QUEANBEYAN TRANSFER STATION

NOISE IMPACT ASSESSMENT

REPORT NO. 13246
VERSION B

From: Andrew Wild <andrew.wild@wildenvironment.com.au>
Sent: Monday, 30 November 2015 11:23 AM
To: Jacinta Tonner
Cc: jason.stewart@suez-env.com.au; Rebecca Smith
Subject: TRIM: DA 2015/338: Response to EPA and RMS Submissions
Attachments: WE-184 Gilmore Rd (Queanbeyan West)-TechNote-R1-0.pdf; 13246-R Ltr 291115 NH.pdf; 13246 Report VerB Final.pdf

Figure 1 Sensitive Receivers

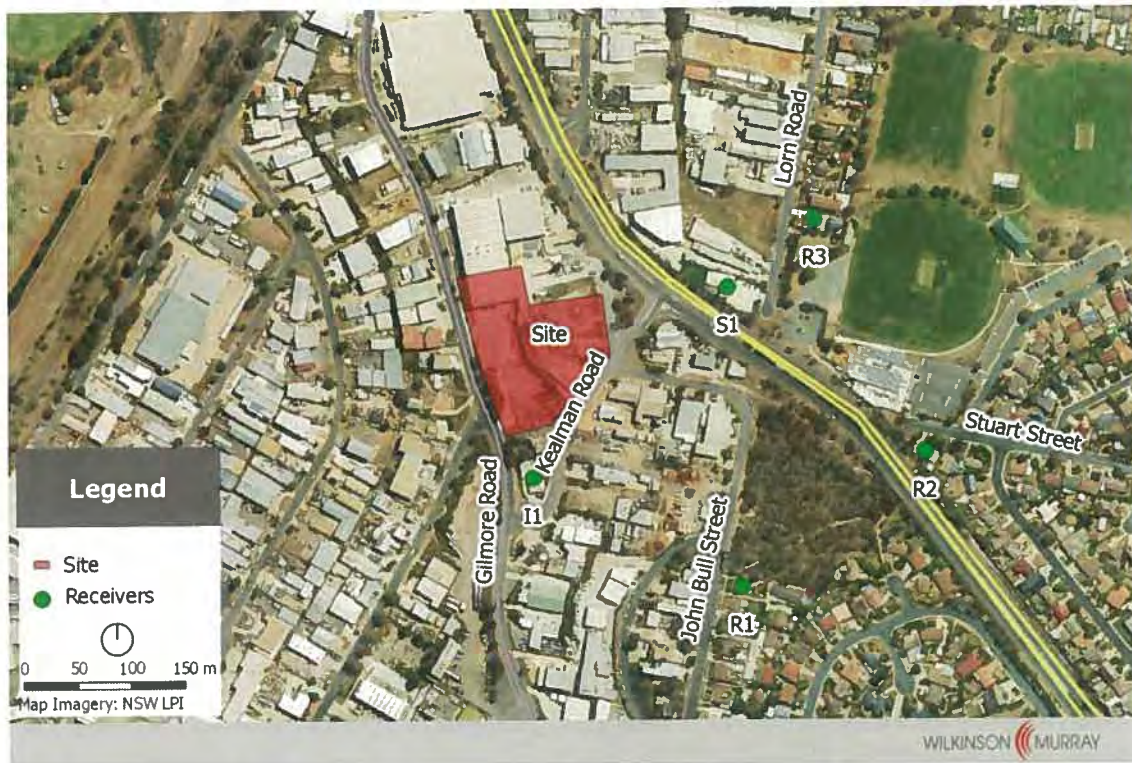
Submission	Response	References
<p>The Noise Impact Assessment (NIA) identifies the nearest residential receiver locations to the project in Table 2.1 as R1, R2 and R3, whilst Table 5.3 indicates 6 receiver locations. Further, EPA noted in its review of documentation regarding a proposal to treat medical waste at the same site, the information identified two additional residential dwellings located within the industrial estate on Kendall Avenue and Bayldon Road that do not appear to have been considered in this NIA.</p> <p>The EPA requests the NIA be revised to clarify the exact number and location of "sensitive receiver locations" and demonstrate the Project will not result in noise impacts at these locations</p>	<p>The reference to 6 residential receivers in Table 5.3 (NIA, Version A) is a typographical error.</p> <p>No sensitive receivers have been identified in the industrial estate on either Kendall Avenue or Bayldon Avenue. However, it is understood that a dwelling is located at 1 Kealman Road, approximately 35 metres from the boundary of the project site.</p> <p>The updated NIA (Version B, dated 27 November 2015) identifies the most sensitive receivers in the vicinity of the project site, establishes noise criteria at each receiver location in accordance with relevant NSW Government guidelines, and demonstrates that the project is unlikely to result in noise impacts at the most sensitive receivers.</p>	NIA – Chapters 2, 5 & 6

The school is located at 67 Lorn Road, Queanbeyan, and is shown as S1 in Figure 1. The INP recommends an acceptable internal L_{Aeq} noise level of 35 dBA for school classrooms, during the busiest one hour period when the room is in use. The noise model used in the NIA predicts external noise levels, and therefore, for the purposes of assessment, it is useful to convert the acceptable internal noise level to an external noise criteria. The attenuation of noise through a partially open window is approximately 10 dBA. Accordingly, an external L_{Aeq} noise criteria of 45 dBA has been adopted for the school.

Figure 1 Sensitive Receivers

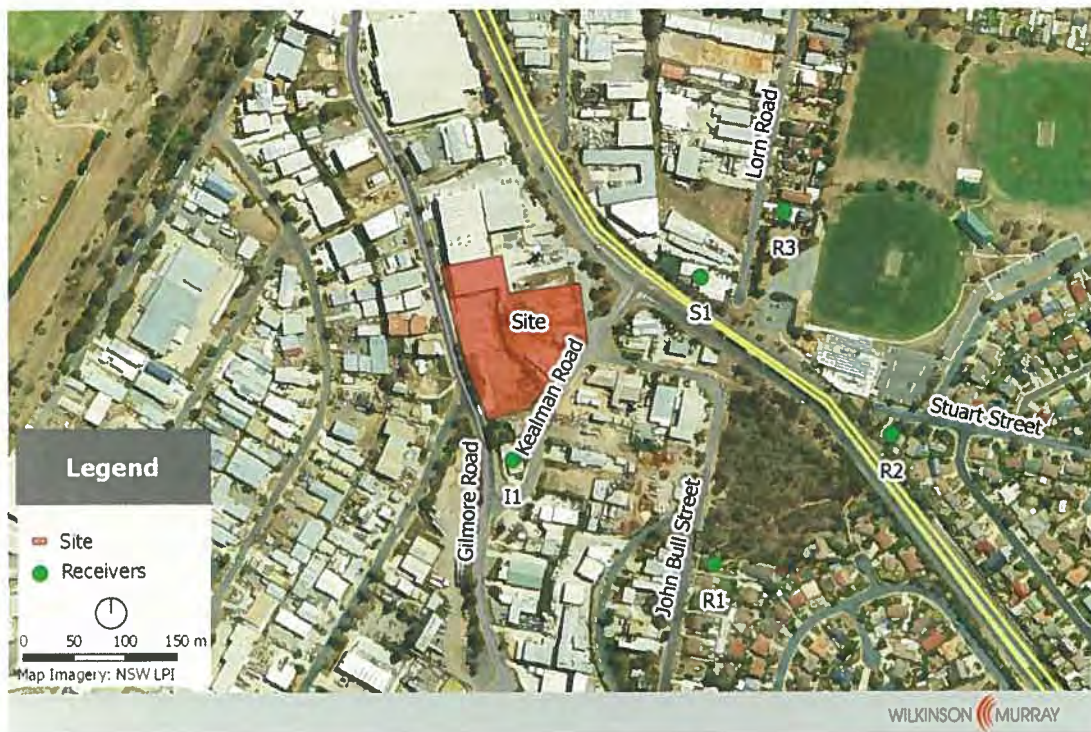
No	Information Request	Response
		will be provided in the resource recovery hall.
6	Revise the Noise Impact Assessment (NIA) to clarify the exact number and location of 'sensitive receiver locations' and demonstrate the proposal will not result in noise impacts at these locations.	Please refer to the revised NIA (revision B), previously sent to QCC.
7	The revised NIA must account for a school at 67 Lom Road and demonstrate the classrooms can meet the recommended acceptable level of 35dB(A) with a maximum limit of 40dB(A) during the noisiest 1 hour period when the room is in use.	Please refer to the attached letter from Wilkison Murray (13246).
8	Provide evidence of the existing traffic movements for Stage 1 to justify the assumptions and prediction of the impact Stage 2 will have on the road network. A SIDRA analysis may still be required.	Council have provided the details of the RMS Regional Land Use Planning Unit in Wollongong. Our Traffic and access specialists, Auswide Consulting, are in the process of consulting RMS. As requested by Council, all email and other correspondence will be copied to Council.

The school is located at 67 Lorn Road, Queanbeyan, and is shown as S1 in Figure 1. The INP recommends an acceptable internal L_{Aeq} noise level of 35 dBA for school classrooms, during the busiest one hour period when the room is in use. The noise model used in the NIA predicts external noise levels, and therefore, for the purposes of assessment, it is useful to convert the acceptable internal noise level to an external noise criteria. The attenuation of noise through a partially open window is approximately 10 dBA. Accordingly, an external L_{Aeq} noise criteria of 45 dBA has been adopted for the school.

GROUND FLOOR PLAN
1:200

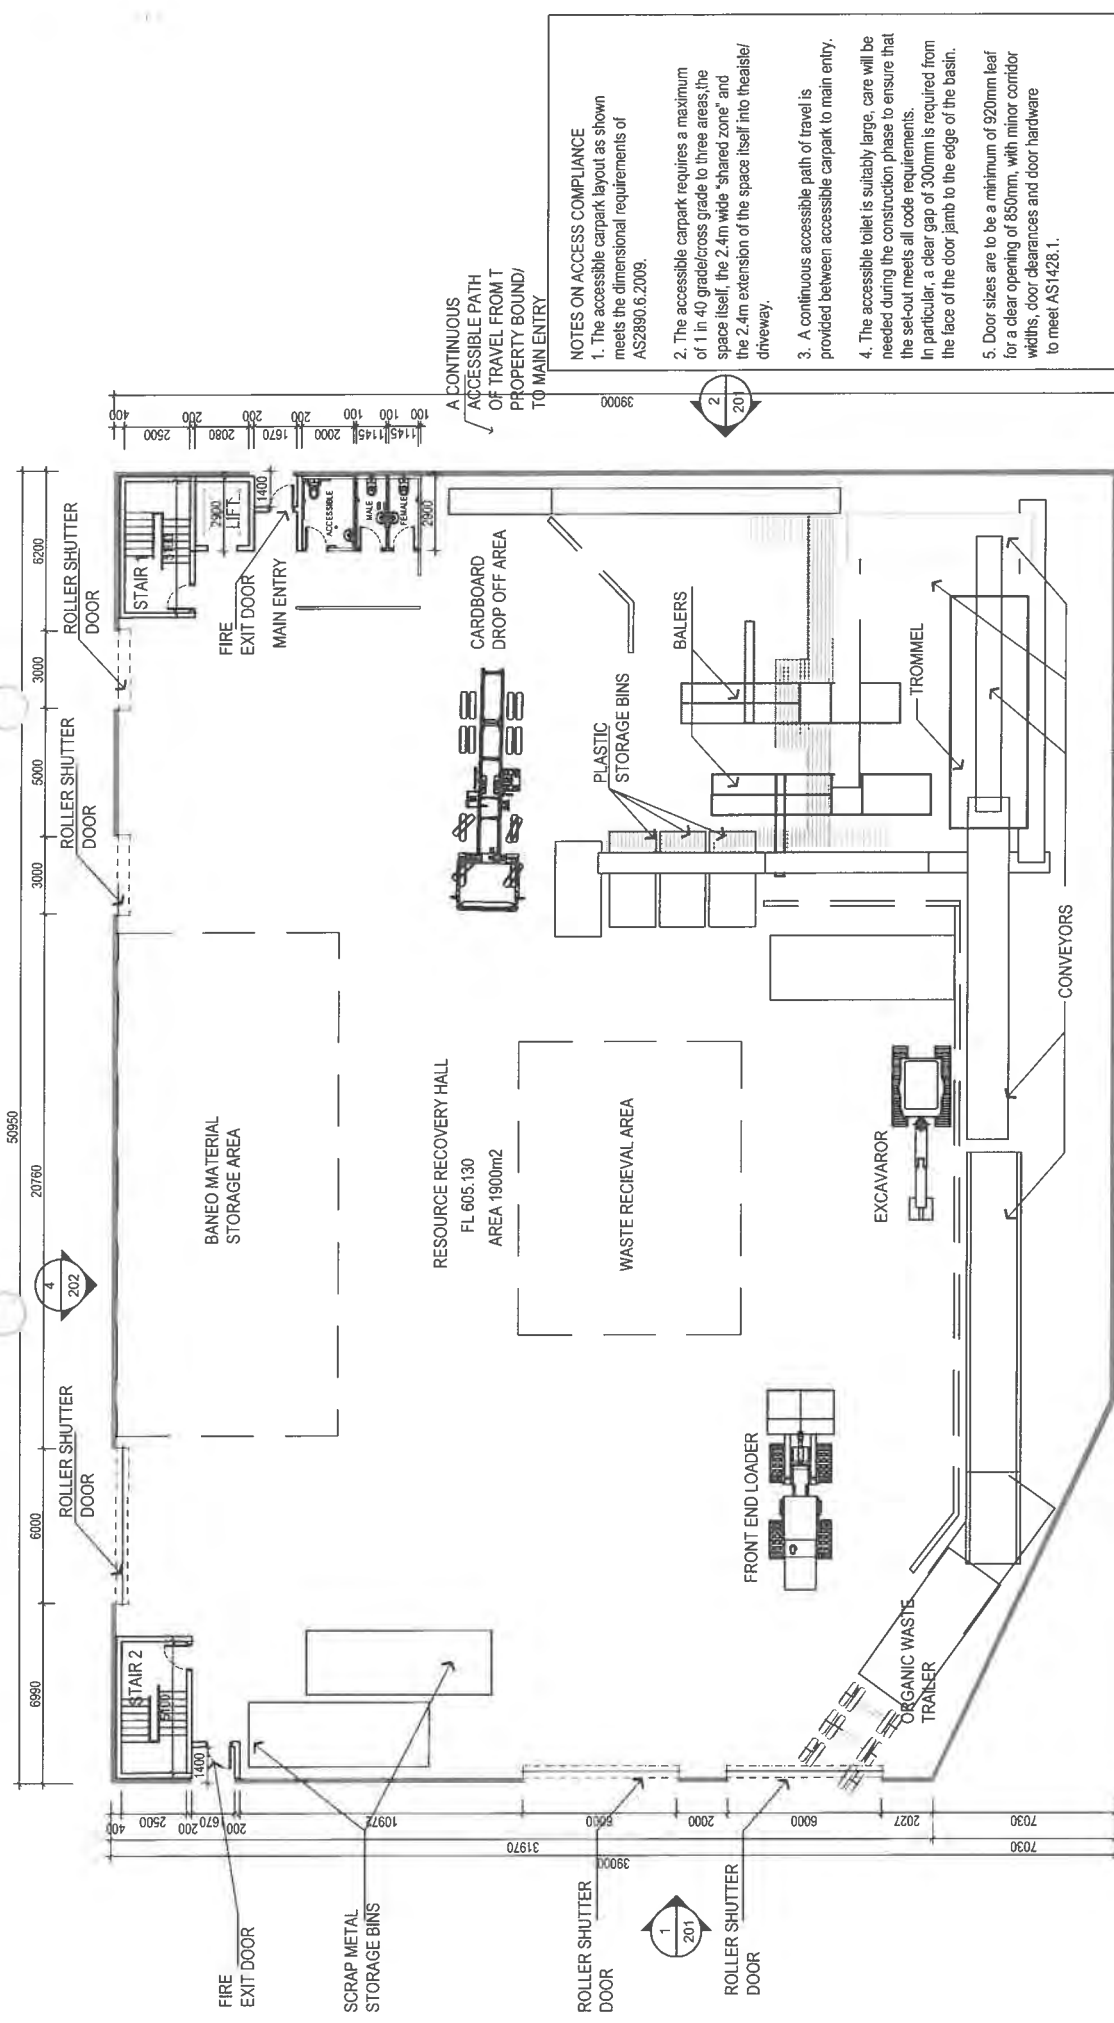
No	Information Request	Response
1	Exits provided from the basement carpark area within the resource recovery hall must comply with the requirements of <i>National Construction Code (NCC) Volume 1, Part D1 – Provision for escape</i> . The roller doors servicing the resource recovery hall are not suitable exits as per the requirements of the NCC.	Noted: the concept design presented in the DA allows for escape exits. During the detailed design and construction certificate stage, exits will be provided within the resource recovery hall that comply with the requirements of the NCC.
2	An accessible carpark space is to be provided in the proposed basement carpark area.	Noted; the concept design presented in the DA allows for accessible carpark spaces. During the detailed design and construction certificate stage, it will be noted that an accessible carpark space will be provided within the basement carpark.

REV. A 08/07/2015 — ISSUED FOR DA
REV. B 05/02/2016 — PLAN AMENDED, NOTES ADDED
REV. C 16/02/2016 — FIRE ESCAPE STAIRS, ACCESSIBLE TOILET AND LIFT, A CONTINUOUS ACCESSIBLE PATH OF TRAVEL FROM THE PROPERTY BOUNDARY TO MAIN ENTRY ADDED, NOTES ADDED.

BASEMENT PLAN
1:200

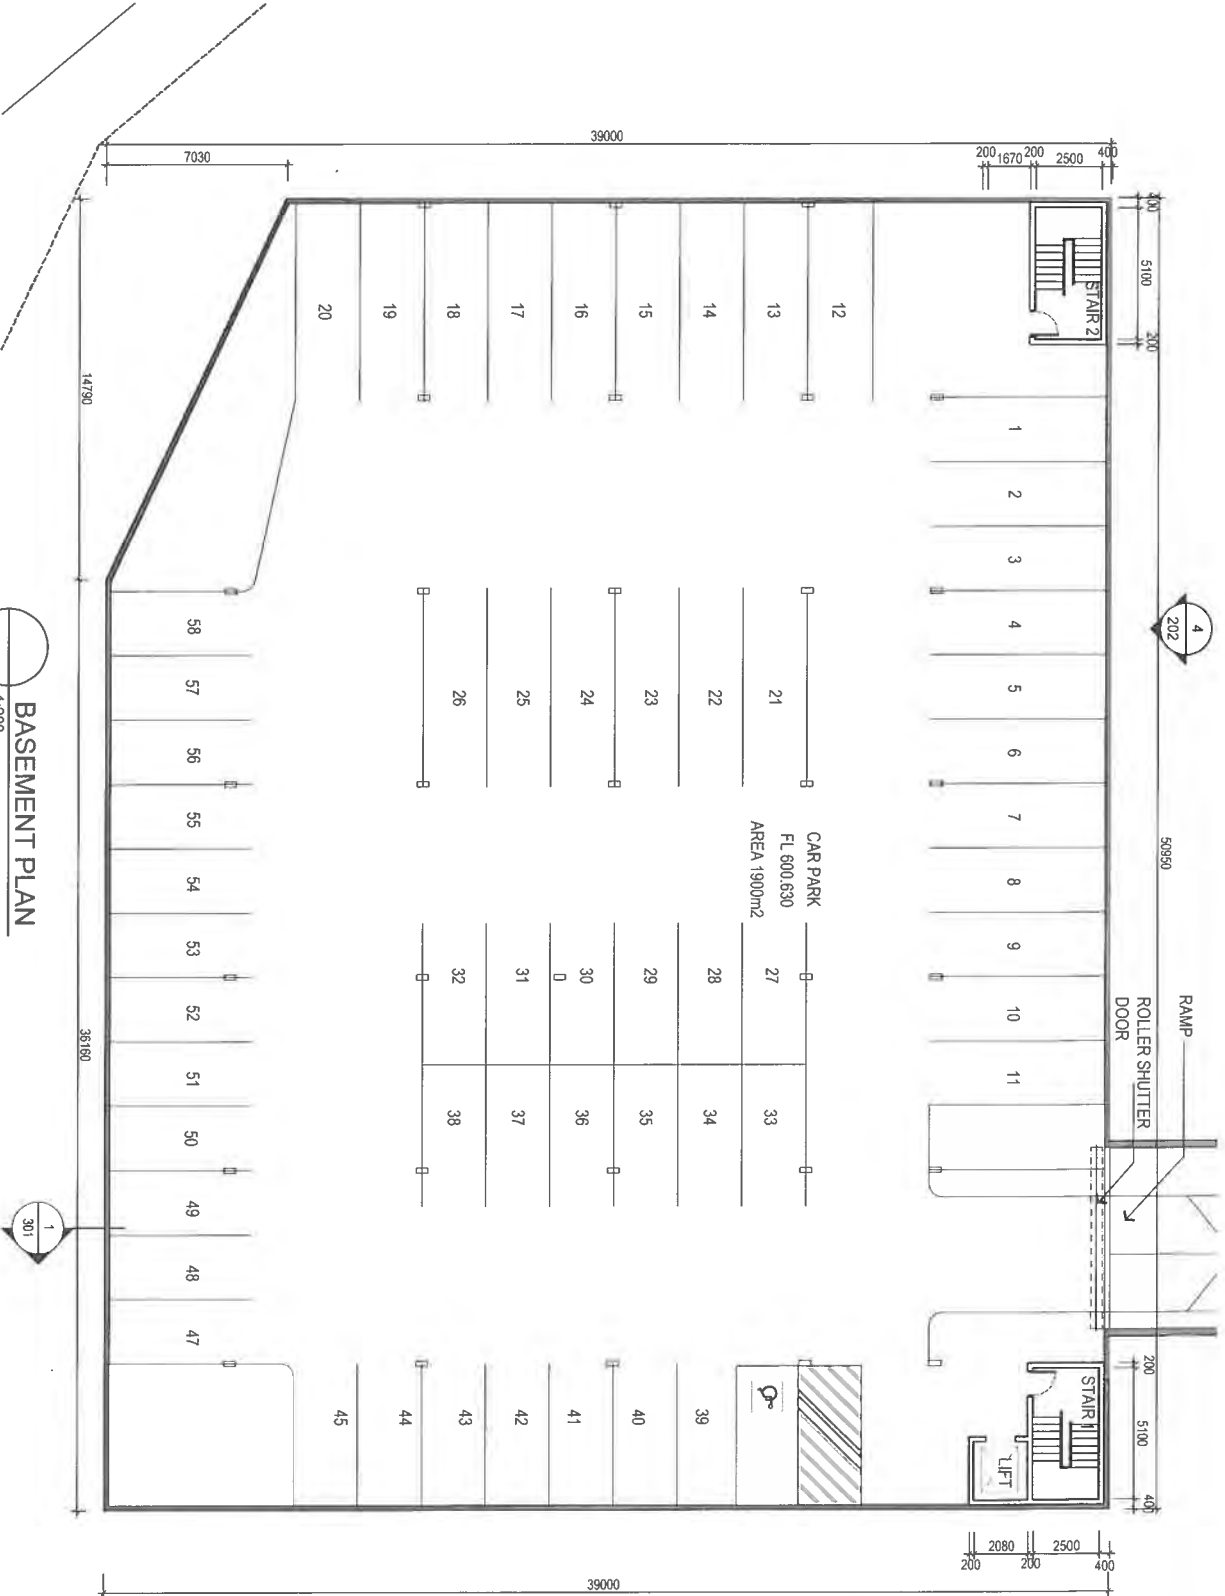
3	A lift or ramp capable of providing access for people with disabilities is to be provided from the accessible carpark space in the basement to the resource recovery hall.	Noted (refer attached Plan-Basement). During the detailed design and construction certificate stage, a lift/ramp providing access for people with disabilities will be provided from the accessible carpark space to the resource recovery hall.
4	Access for people with disabilities is to be provided from the property boundary to the principle entrance to the resource recovery hall.	Noted. During the detailed design and construction certificate stage, access for people with disabilities will be provided from the property boundary to the principle entrance to the resource recovery hall.
5	An accessible unisex sanitary facility and 1 male and 1 female sanitary facilities are to be provided in the resource recovery hall.	Noted (refer attached Plan – Ground Floor). During the detailed design and construction certificate stage, an accessible unisex sanitary facility and 1 male and 1 female sanitary facility

REV. A - 06/07/2015 - ISSUED FOR DA
REV. B - 14/02/2016 - FIRE ESCAPE STAIRS, ACCESSIBLE CARPARK AND ACCESSIBLE LIFT ADDED
